***Centre for Obesity, Diabetes and  
Cardiovascular Disease,  
The University of Sydney***

***MP 09\_0051 MOD 2 – Modification to the  
design of the approved CODCD building***

Director-General's  
Environmental Assessment Report  
Section 75W of the  
*Environmental Planning and Assessment Act 1979*

March 2012

**Figure 7:** Ground level footprint diagram of CODCD currently proposed.

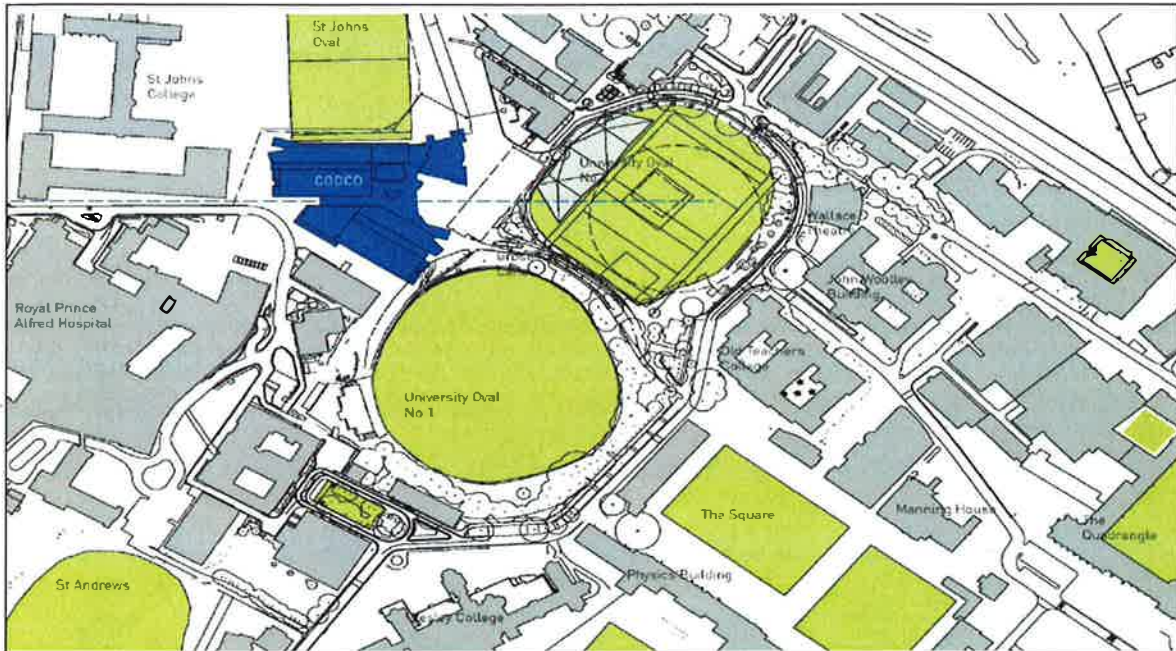
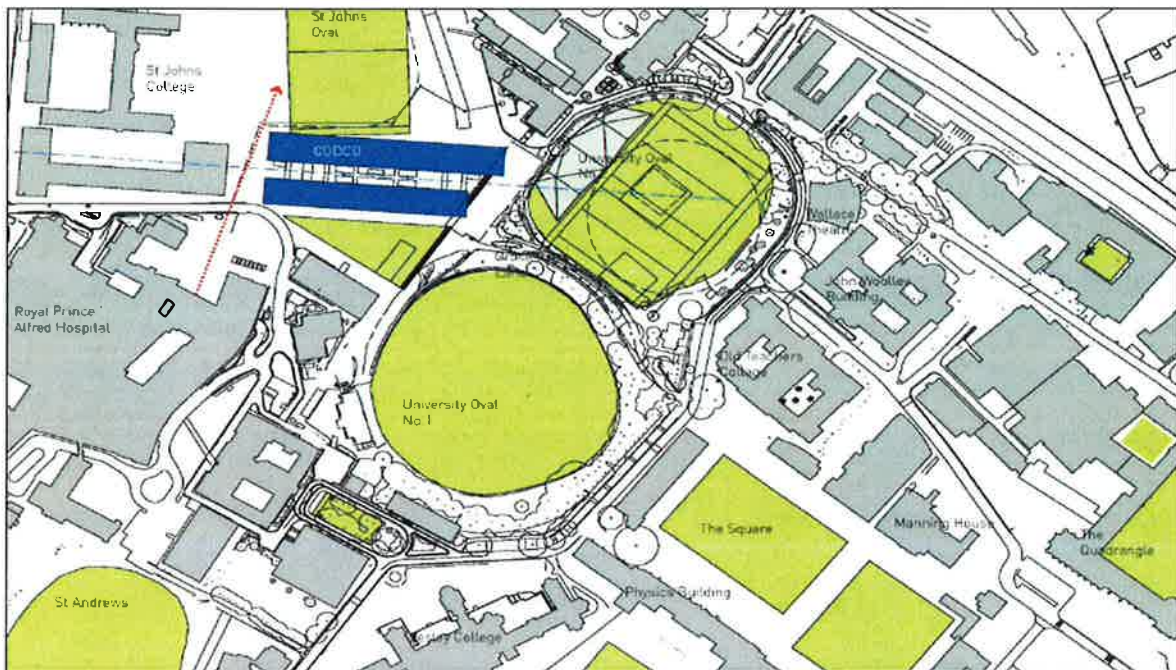
The proposal to alter the external design and shape of the approved building, reducing its size and bulk, is considered an improvement to the approved scheme. The proposed reduced building footprint adjoining the Centenary Institute Building also creates an opportunity to provide a consolidated open space area at the southern junction between the Sydney University Campus and Royal Prince Alfred Hospital, improving the spatial and visual relationship between the two sites.

While the alternative building design is proposed to be extended closer to the university ovals, the deletion of the southern splayed wing for the full height of the approved footprint is considered to have a more significant impact in reducing the visual bulk and dominance of the building and to improve visibility of St John's College. Further, the additional building length is made up of clearly defined and separated building elements to further reduce its apparent additional bulk and height at its eastern end.

The department acknowledges the proposed rectangular shaped building envelope, elongated to the east, is distinct from the wider and irregular shaped building as approved. Notwithstanding, a 7 storey building form with a maximum height of RL 59.1 (including the plant) is maintained as approved to ensure compatibility with roof heights of adjacent buildings.

**Figure 6** and **Figure 7** below provide a visual comparison between the building footprint of the approved and proposed CODCD facility showing the greater building setback from the Centenary Institute Building to the south.

The department considers that overall the proposal better relates to its surrounds and therefore is accepted in its current form.

**Figure 8:** Section of revised CODCD including basement footprint over 3 levels, single storey café / pavilion to provide access to below ground theatre / café within open space plaza and adjacent Centenary building.

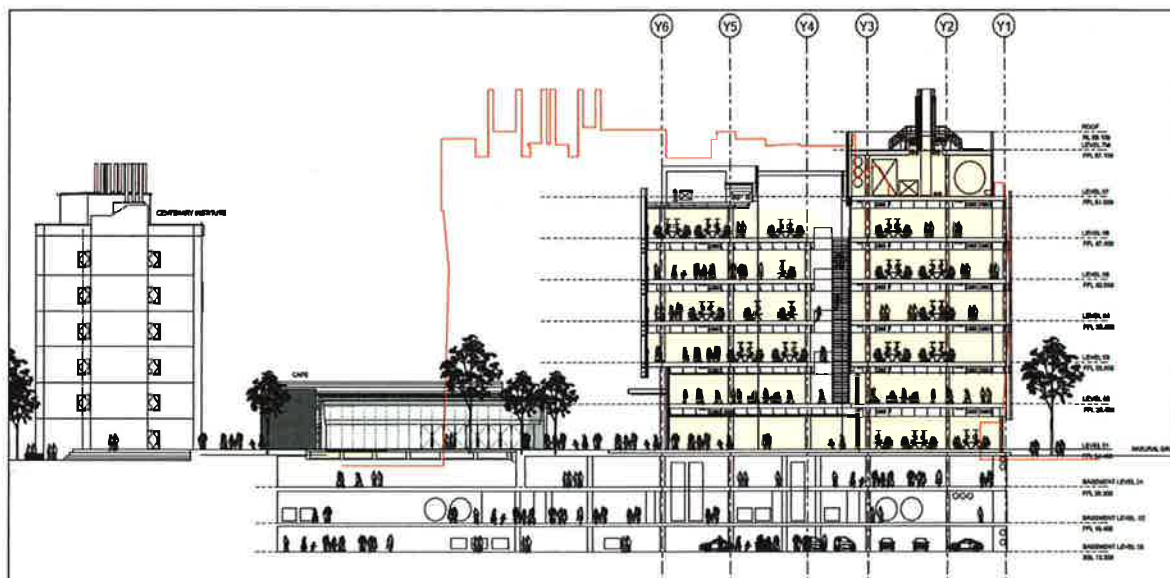
The internal floor configuration has been amended to suit the linear and elongated building footprint broken into two wings separated by a central atrium space (refer to **Figure 8** below). The department acknowledges the improvements to the internal floor layout provide benefits for workplace amenity from an integrated floor plan and natural daylight access. The department notes the detailed design of the building does not alter the principal purpose of the CODCD as a medical and educational facility and or the specific operational needs of the building (research, education and ancillary support areas). A comparison of the floor areas and functions for the CODCD as approved and as modified are provided in **Appendix B**.

The basement parking area has almost halved in area compared to the last application (refer to **Appendix B** for areas) despite additional excavation required to lower the building to bedrock (to improve vibration sensitive areas of medical imaging) and accommodate an additional basement level (B3). The decrease in the basement area is attributed to the reorganisation of the basement component to minimise building over a Sydney Water easement. The basement is now proposed over 3 levels in order to accommodate the existing number of spaces for parking/servicing and bicycle parking (refer to **Figure 8**).

The department is satisfied that the modified design changes are refinements to the operational aspects of the building which will not change the principal purpose and or intensity as originally approved.

**Figure 9:** Visual comparison of improvement on encroachment on alignment of the southern wing of St John's College as originally submitted and as amended compared with that approved.

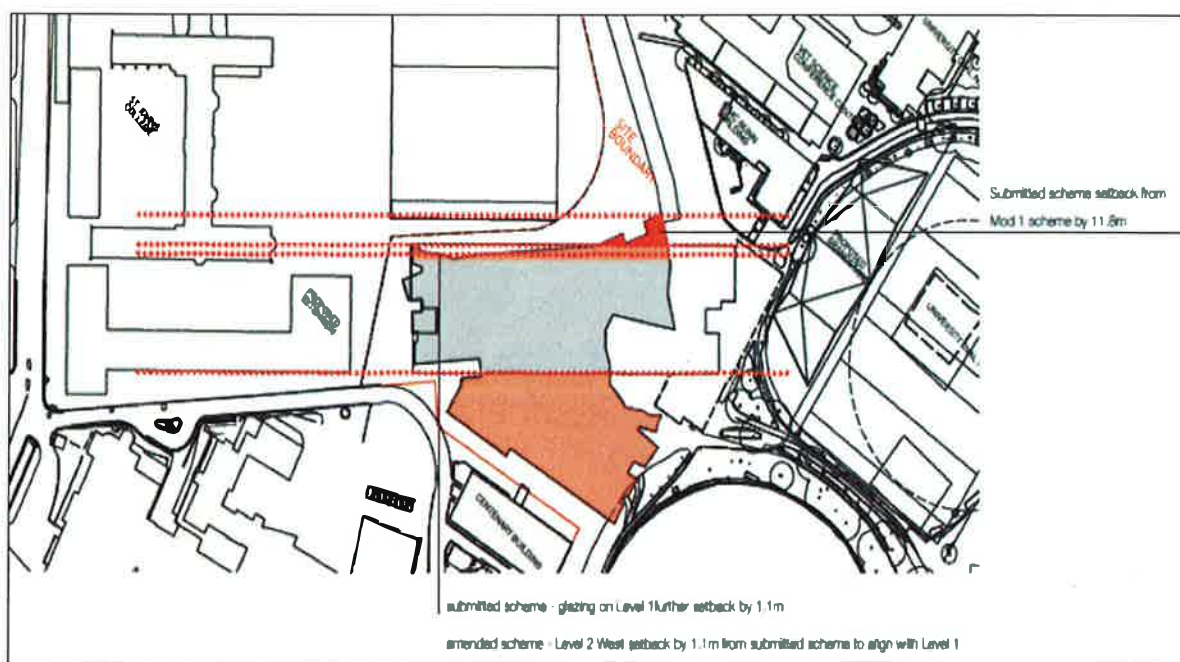
The modified building will be within the view arc of St John's College. **Appendix E** shows the view corridor identified in the original CMP 2001 extending from the north-west to the north-east. Council advise the northern façade does not follow the alignment of the southern wing of St John's College identified as an important view corridor in the CMP 2001. Further, Council advise while

neither the approved or modified scheme matched this alignment, the modification application presents an opportunity to reduce the heritage impacts of this development.

- the original approval maintains the north west to north east view corridor with some impact on the north east view corridor identified in the CMP 2001. The modification reduces this encroachment and improves the spatial relationship of the building (linear building form) over that approved by providing a set back in the north east and north west corner areas along the northern building alignment from that approved. **Figure 9** provides a visual comparison of improvement on the encroachment by the current modification as originally submitted and as amended (8 February 2012) when compared with that approved;

- the proposed setback of the building alignment of the ground and first floor level in the corner locations, creates a view corridor not previously available (as approved and or modified in the context of the amended CMP for St John's College) along the northern elevation to St Johns College;

- the further encroachment of the building beyond the projected alignment of the southernmost wall of St Johns College is limited to the upper levels (level 3 to parapet) where pedestrian views of the local heritage item are unavailable and will not result in additional impacts on the College Building;

**Figure 10:** Visual comparison of improvement to encroachment of views beyond the southern wall alignment of St John's College by the current modification when compared with that approved.

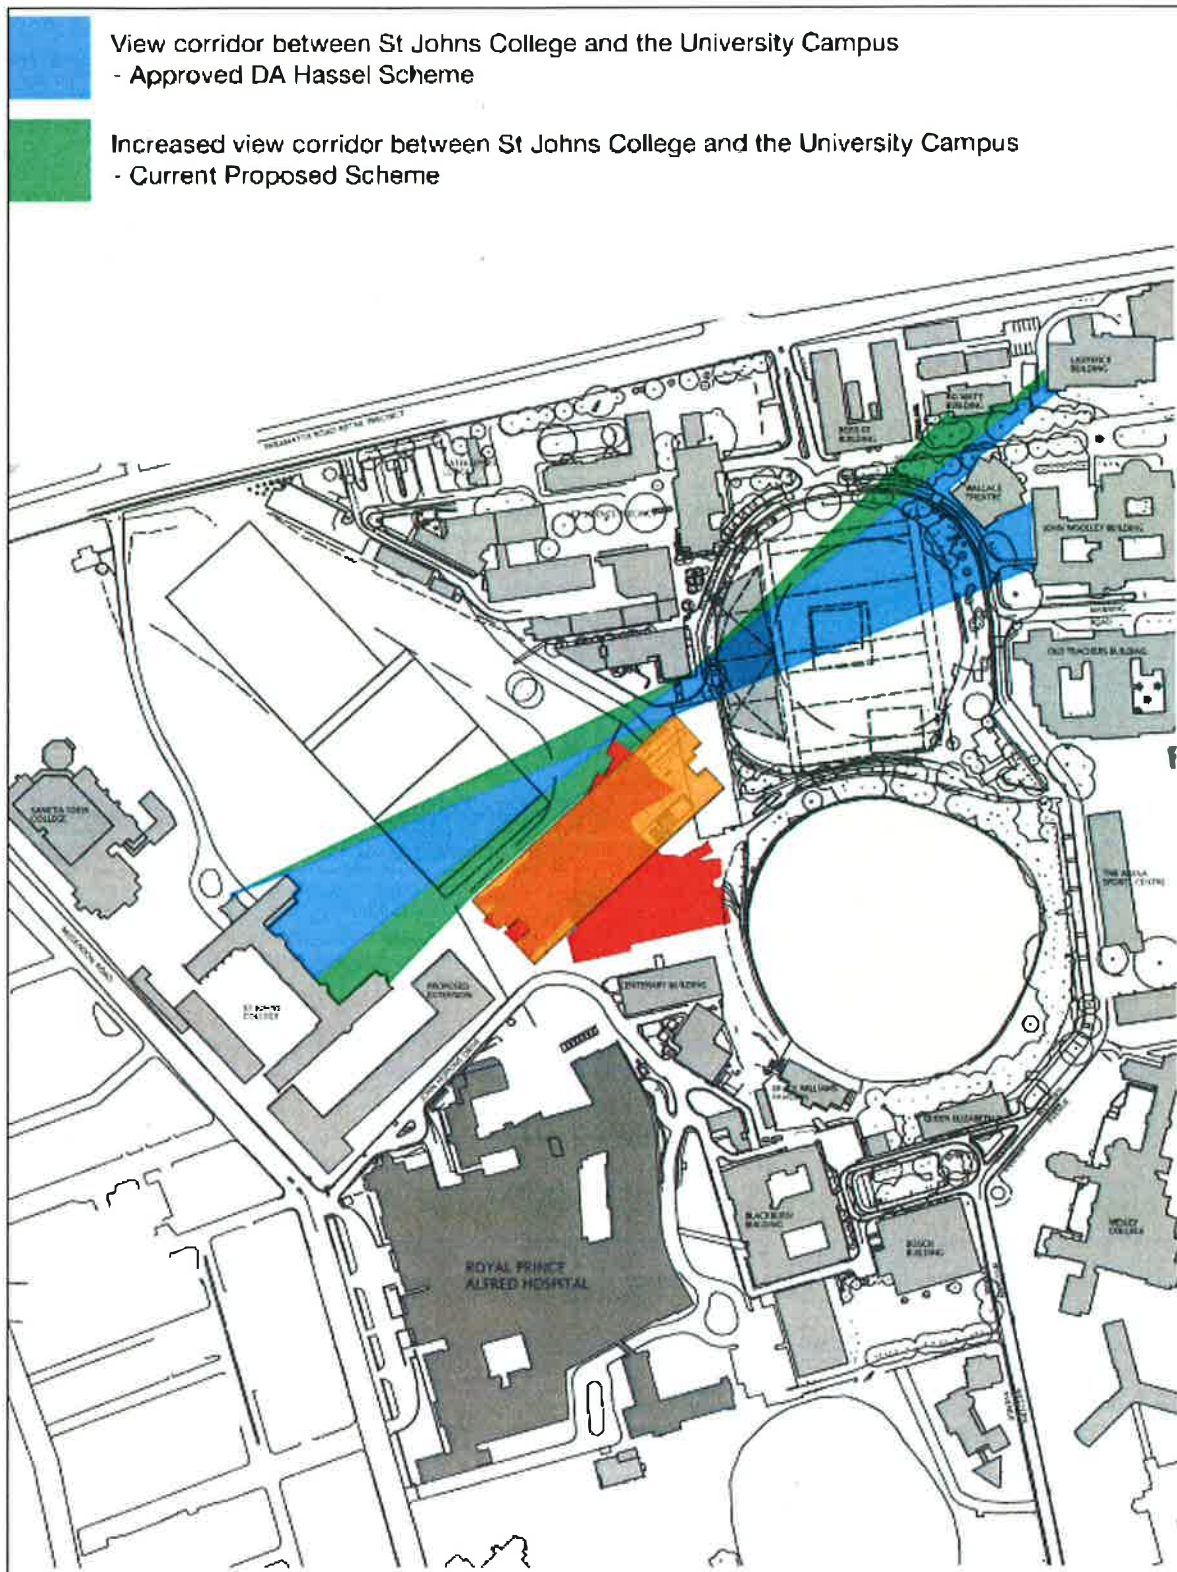
- having regard to the surveyed significant views and vistas identified in the CMP 2010 Addendum, the proposal retains views of St John's College from the north, north east (principal views) and to the east elevation from the ovals (refer to **Figure 10** below);

The department has considered the revised design, footprint and reduced bulk and scale of the amended proposal and is satisfied that the modified building will not result in additional material visual impacts on the setting of St John's College and the Royal Prince Albert Hospital buildings for the following reasons:

- the modification does not alter the 60m setback distance of the approved building siting from St John's College. In this respect, the curtilage and main public view corridor from Parramatta Road to St Johns College identified in the CMP Addendum is not affected;

**Figure 14:** *Creation of increased, useable public open space (including single storey café/pavilion entry to basement level theatre) and linkages between the university campus and the Royal Prince Alfred Hospital Group of Buildings.*

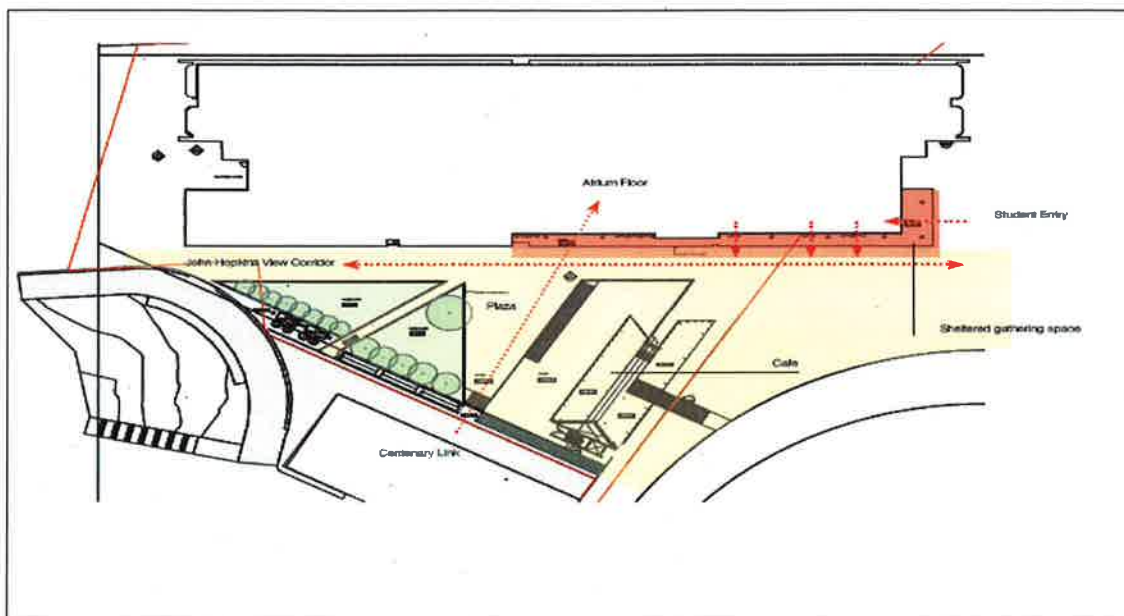
As discussed, the proposal creates an opportunity to provide a consolidated open space area, between the CODCD building and the Centenary Institute Building to the south, at the interface between Royal Prince Alfred Hospital and the University sites. This area is supported as it will improve amenity and provide a connection and spatial / visual relationship between the University, Centenary Building and Royal Prince Alfred Hospital (refer to **Figure 14**).

The department considers deletion of the remaining approved pedestrian bridge link between the CODCD building to the Centenary Institute building is reasonable given that the introduction of an open space plaza to the south of the facility provides for direct and at grade pathways between the two facilities. In effect, pedestrian links between the two facilities are maintained by the revised changes to the building form and urban design (refer to **Figure 14**). Further, the retention of the Sir Hopkins Drive adjoining the open space plaza over this part of the site provides a clear connection between the CODCD, Centenary Institute, wider university grounds and the Royal Hospital group of buildings.
